**SINGAPORE CIVIL DEFENCE FORCE
FIRE SAFETY & SHELTER BUREAU
HQ SCDF, 91 Ubi Ave 4 Singapore 408827 Fax: 68481493
Website: http://: www.scdf.gov.sg**

Our File Ref: CD/FSSB/12/01/03/04

16 August 2005

REVISION TO TECHNICAL REQUIREMENTS FOR HS IN LANDED DWELLING UNIT – HS FORM, LOCATION OF BASEMENT HS AND THICKNESS OF HS CEILING SLAB

Figure 1 : Examples of HSs of different shapes (GFA = 100m², HS Size = 2.8m², Number of square units=5)

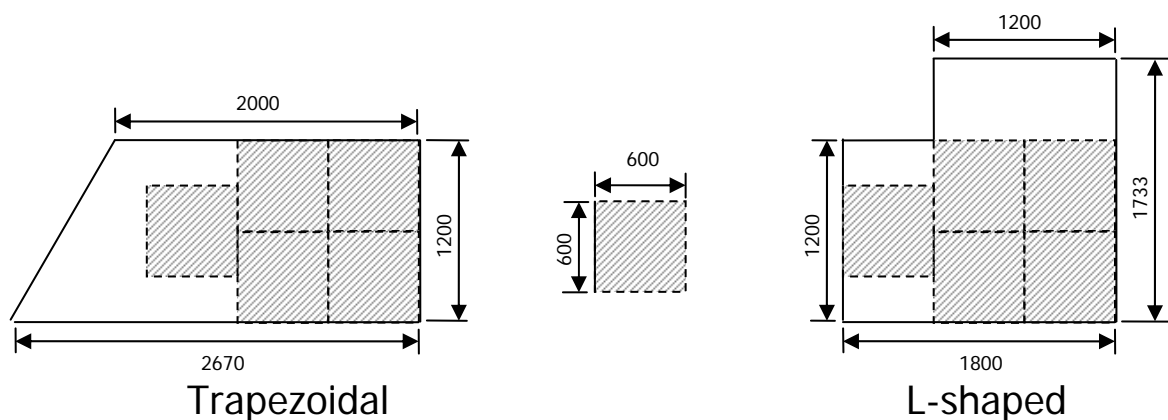
The configuration of a HS or NS on plan shall be rectangular or square. It may also be trapezoidal or L-shaped provided that it must be able to contain the number of 0.6m x 0.6m square units as specified in Table 1, as illustrated in Figure 1.

GFA of Dwelling Unit (m ²)	HS Floor Area (m ²)	Number of square units
GFA ≤ 45	1.6	3
45 < GFA ≤ 75	2.2	4
75 < GFA ≤ 140	2.8	5
GFA > 140	3.4	6

Note: QP has to declare in the drawing submitted to BCA that the HS complies with the abovementioned condition if the HS is trapezoidal or L-shaped.

Figure 2: Minimum dimensions of the ceiling slab of HS in landed dwelling unit

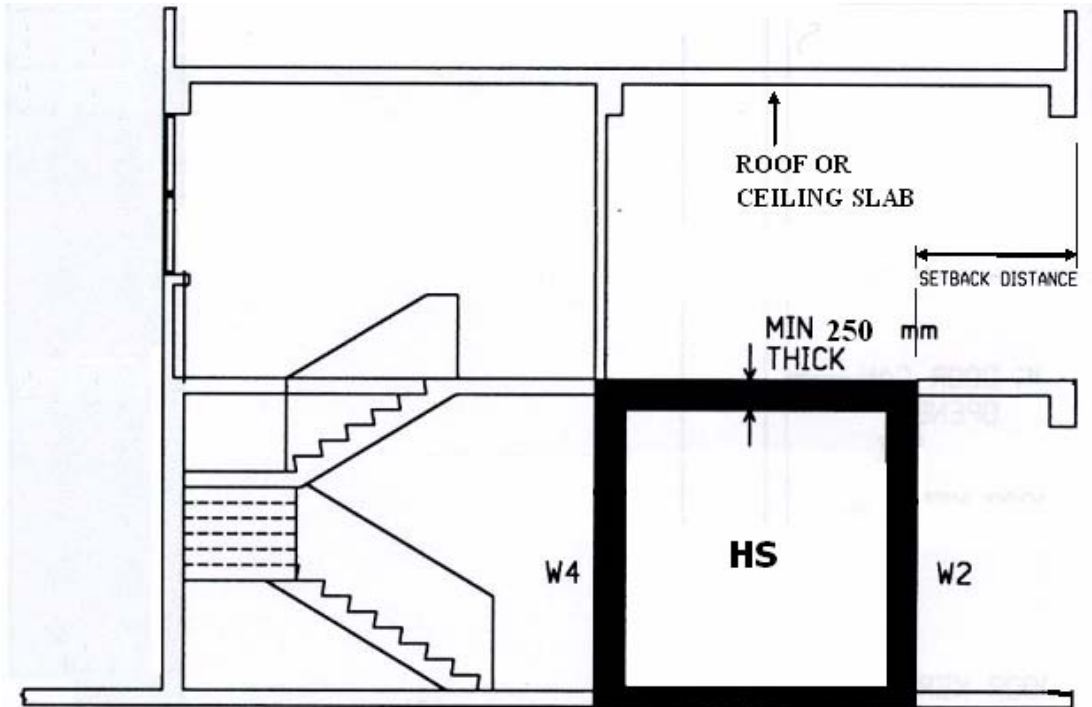
The thickness of the ceiling slab of a HS in landed dwelling unit may be at least 250mm if there is a roof or another ceiling slab above the HS ceiling slab that extends beyond each HS wall to a distance at least equal to that of the setback distance of that HS wall below (See Figure 2).
